March 15, 2022

RE: Village Apartments, LLC
82 Jerome Road, 15 Jerome Ave, and 232 Norwich-New London Turnpike
(CT Route 32)
PZ#22SITE1 Site Plan application

Loureiro Engineering Associates, Inc. (LEA) is in receipt of the review comments prepared by CLA Engineers, Inc. to you, dated February 4, 2022 regarding the Site Plan application for 82 Jerome Road, 15 Jerome Ave, and 232 Route 32.

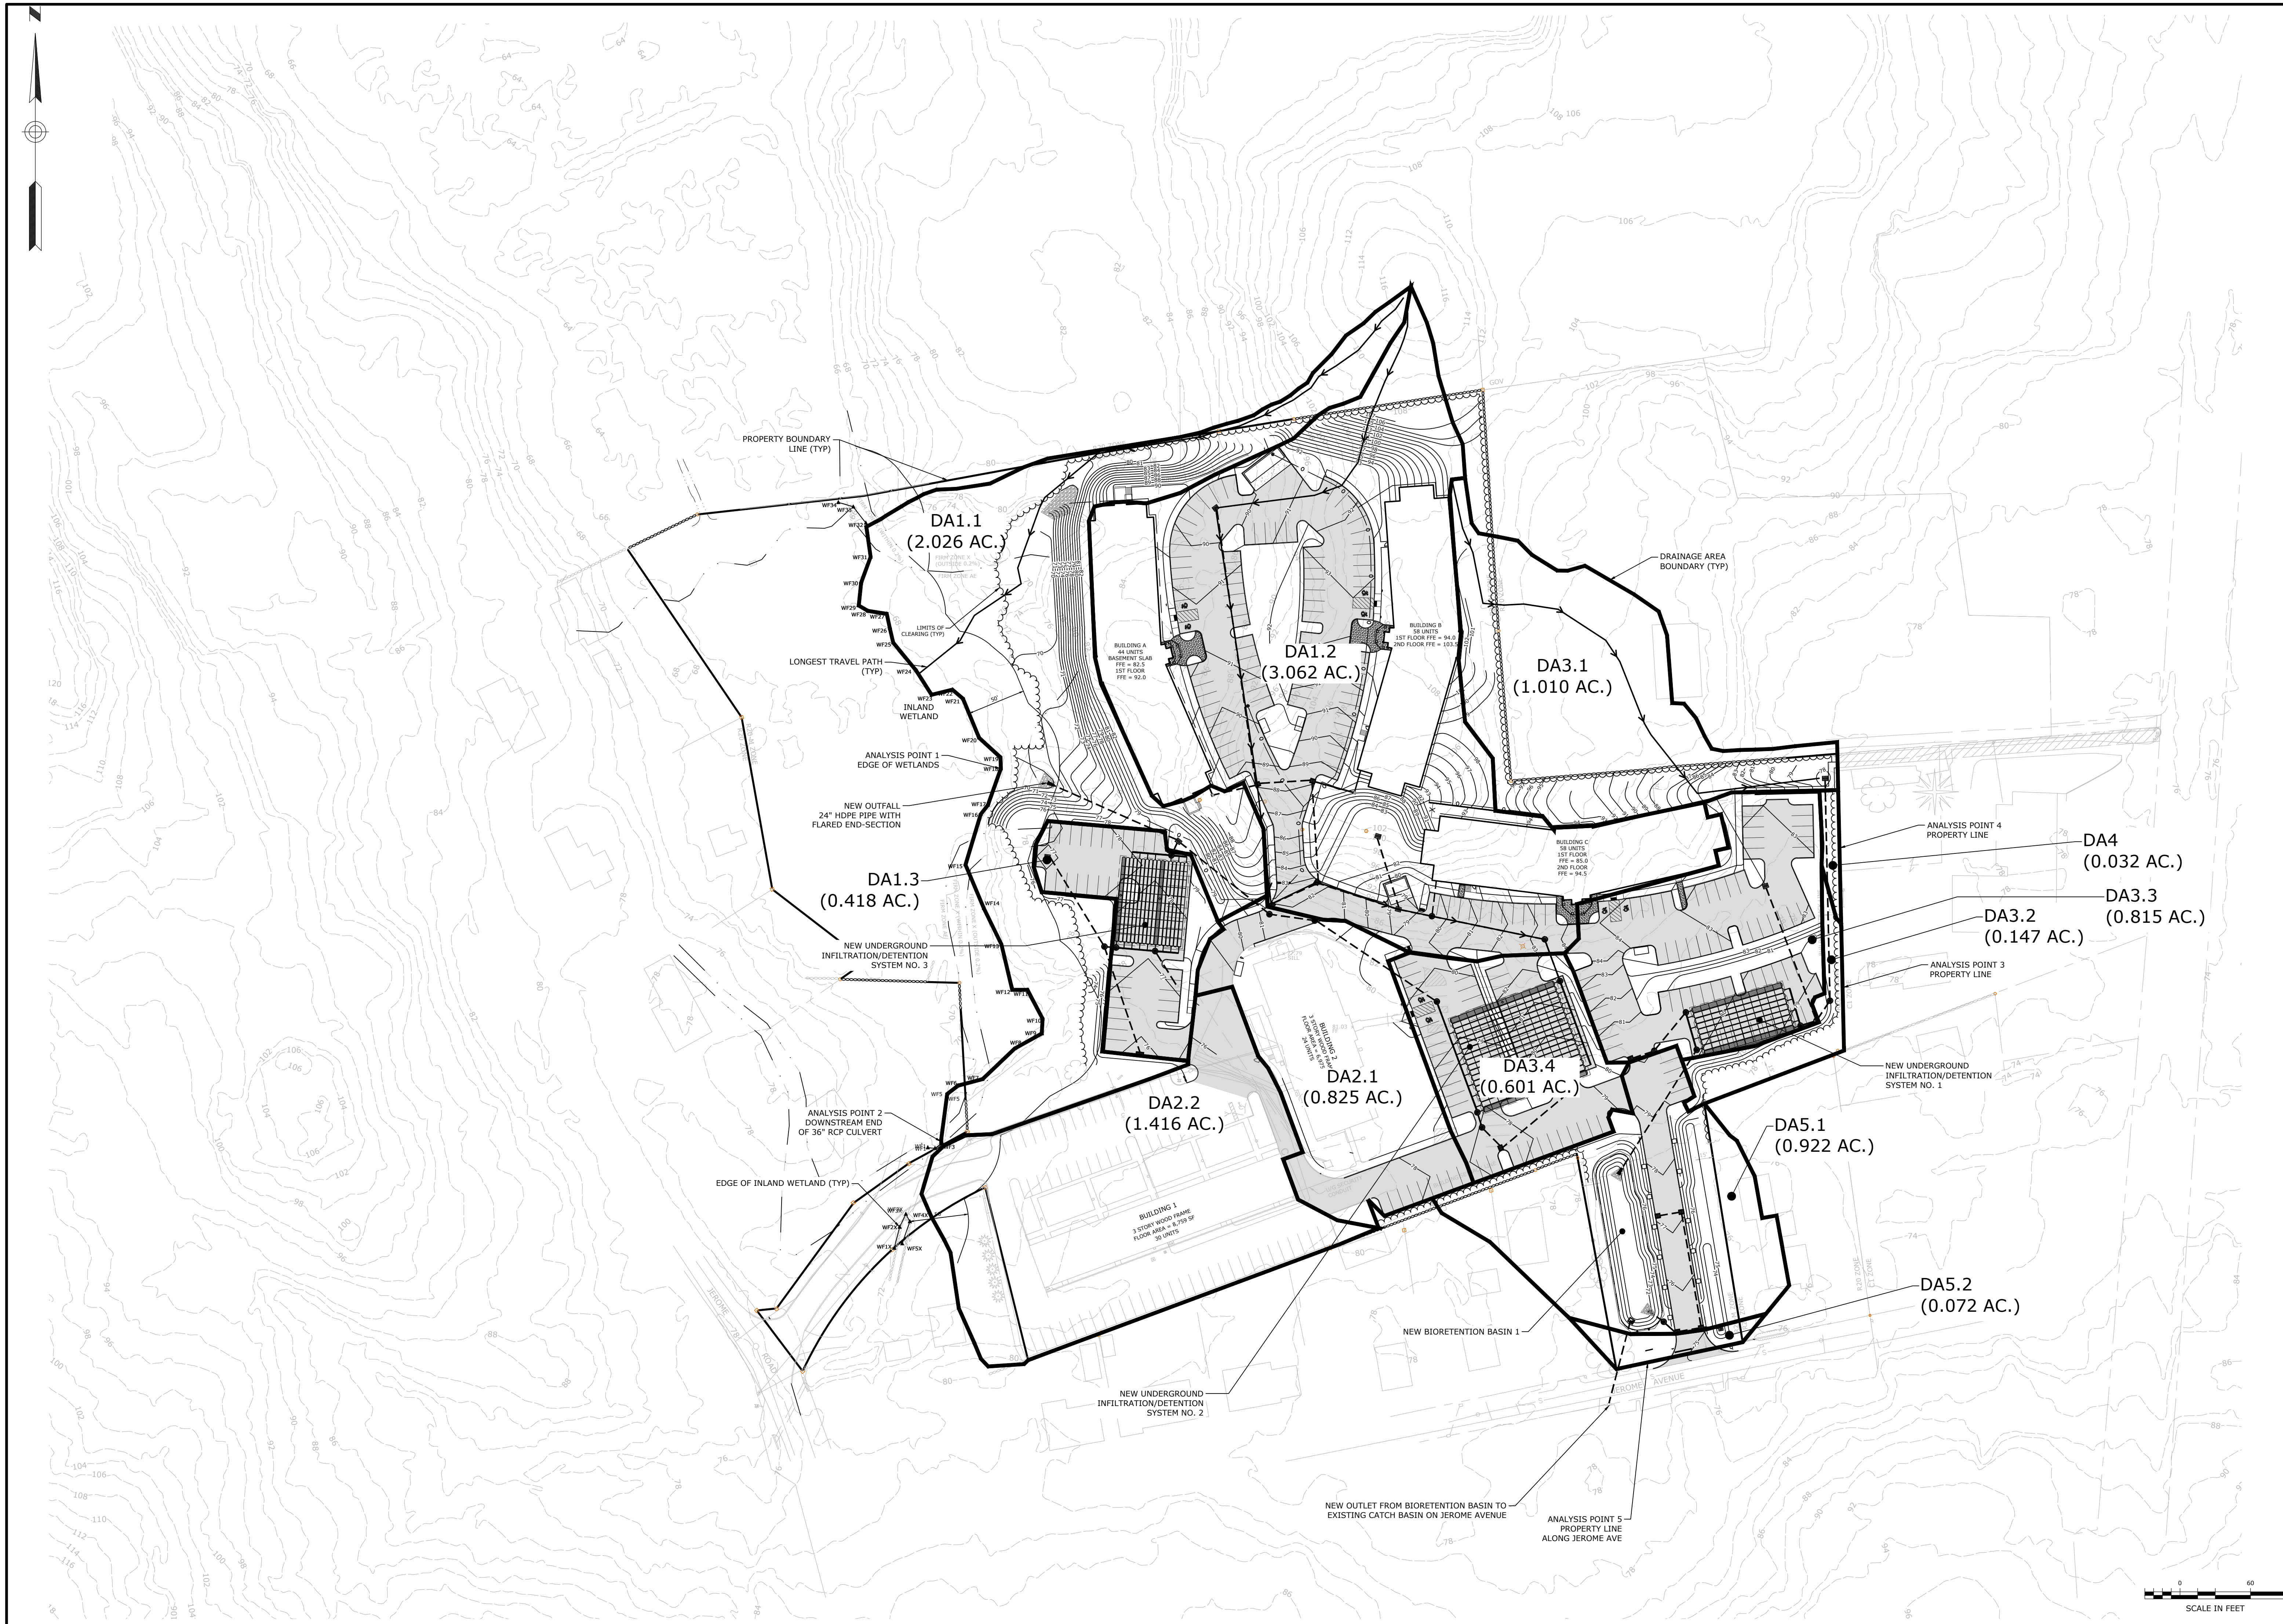
26. The existing drainage at Bldg. 1 outflows directly into wetlands using two curb cuts in the existing access drive, it appears that installing the curb cut at the northwest end of the existing parking area would allow existing drainage to run overland for about 40 feet which would improve the situation.
27. Fig. 4 in the drainage report is illegible.
28. Access to the rear of Bldg's A & B must be less restricted by flattening the proposed 3 to 1 slopes. The area behind Bldg. A must be 15' wide as a minimum prior to the steep sloping.
29. An E&S Bond Estimate must be provided for review.

26. Two additional 5' curb cuts have been added to the east of the existing curb cuts to allow for stormwater runoff to exit the parking lot and flow overland a greater distance before reaching the wetland.
27. Figure 4 has been printed in a 24x36 format and included herewith.
28. A retaining wall with a fence for fall protection has been added behind Building A to allow for a shallow sloped area between the retaining wall and back of the building. In addition, enclosed herewith is a ladder diagram which shows the area to the rear of Building A provides adequate distance for ladder access to the top floor of the proposed building.
29. Pelletier Builders, a wholly-owned subsidiary of Loureiro Engineering Associates, Inc., has provided a Performance Bond Estimate of \$100,000 for the Erosion and Sediment Control Measures for the site.
